TITLE SCHEMATIC
3 WAY SPLITTER BD
CH 2–4 (1198–1607)

DWN	SJM	3/11/93	DWG. NO. 1198–3607	REV 1
CHK	DWB	3/24/93		
REL	DWB	3/24/93	A SCALE ---	SHEET 1 OF 1

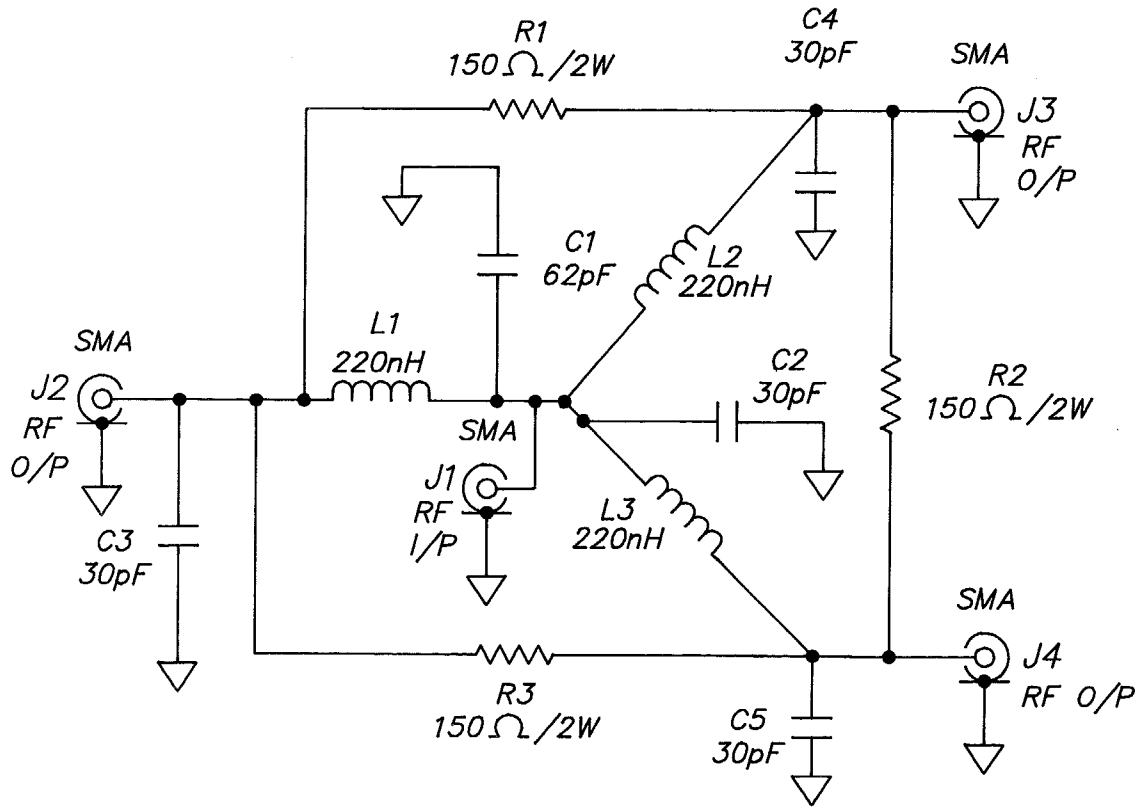
REV	ECN	DATE	APV
1	7280	5/13/93	DWB

C3, C4 AND C5 WERE 24pF. C2 WAS 13pF. L2 WAS L5. SJM
